Canadian Natural Resources Limited

**Application for an Oil Sands Mine,
Bitumen Extraction Plant, and Bitumen Upgrading
Plant in the Fort McMurray Area**

January 27, 2004

**REPORT OF THE JOINT REVIEW PANEL ESTABLISHED BY THE
ALBERTA ENERGY AND UTILITIES BOARD AND THE GOVERNMENT OF CANADA**
EUB Decision 2004-005: Canadian Natural Resources Limited, Application for an Oil Sands Mine,
Bitumen Extraction Plant, and Bitumen Upgrading Plant in the Fort McMurray Area
January 27, 2004

Figure 1. Horizon oil sands project area

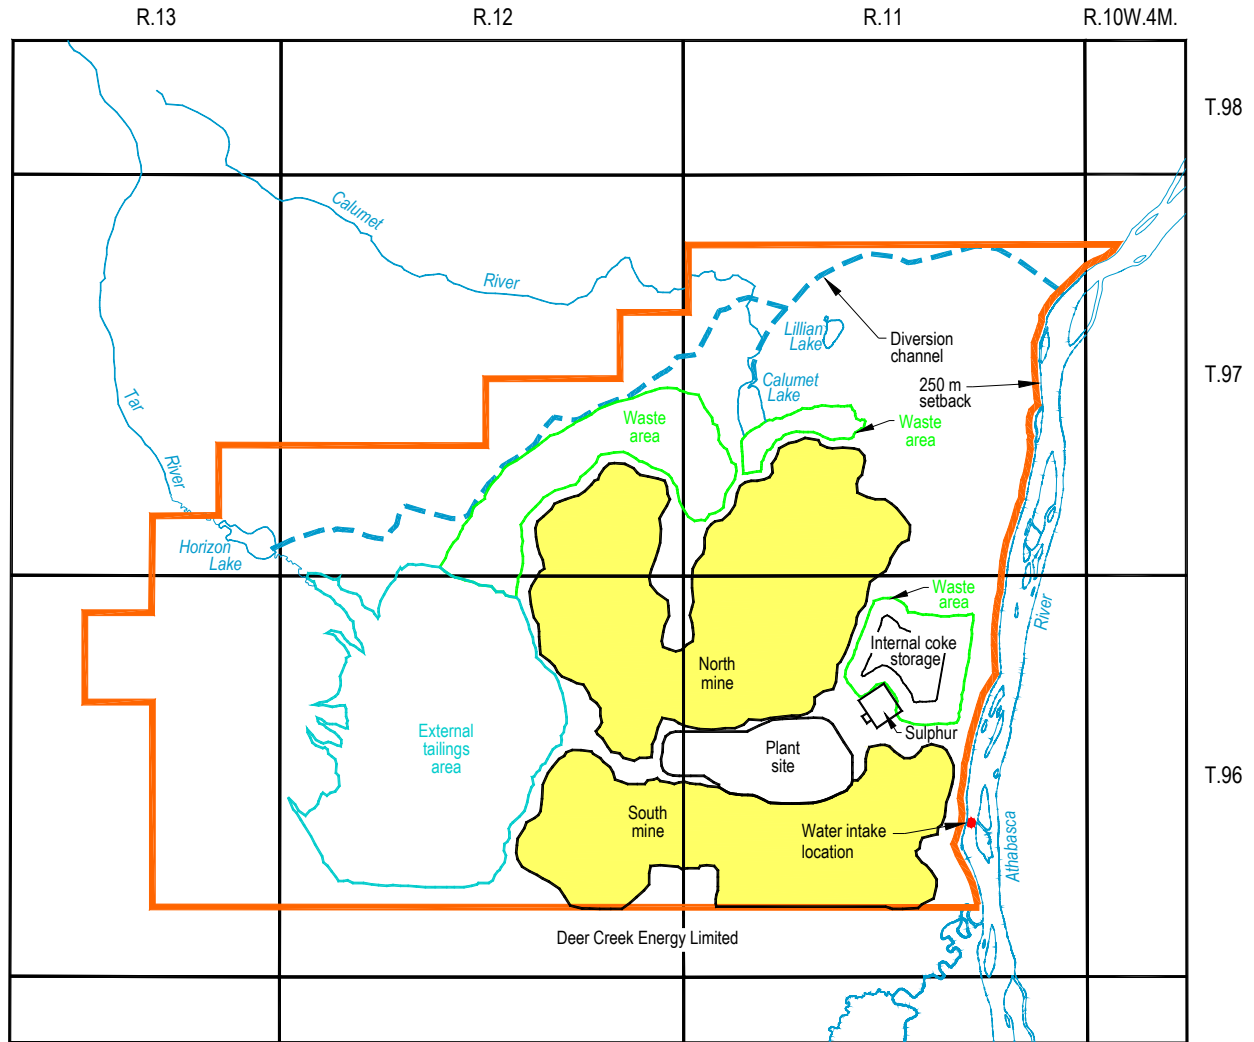
As a result of the concerns regarding foundation conditions, CNRL relocated its proposed plant site northward to the location shown on Figure 1. CNRL believed that the new plant site location would address the geotechnical concerns associated with the originally proposed site, since Clearwater clays were absent in portions of the new location. It recognized that construction of the plant in the new location would result in the sterilization of approximately $53.9 \times 10^6 \text{ m}^3$ of recoverable bitumen, $11.4 \times 10^6 \text{ m}^3$ more than the original site. However, CNRL indicated that its analysis showed that the additional costs associated with the original plant site exceeded the value of the additional foregone bitumen resources associated with the new plant site.

The Panel therefore finds that CNRL has justified the additional resource sterilization beneath the new plant site. Notwithstanding the overall acceptance of the proposed plant site, the Panel believes that since the layout of the plant site facilities remains to be finalized, some reduction in size may be realized through optimization of facilities. It therefore directs that six months prior to the construction of the plant site, CNRL shall submit a report to satisfy the EUB that all reasonable efforts have been made to optimize the plant site area with respect to the minimization of resource sterilization. The Panel notes that any additional oil sand sterilization resulting from an increase to the plant site area would require prior EUB approval.
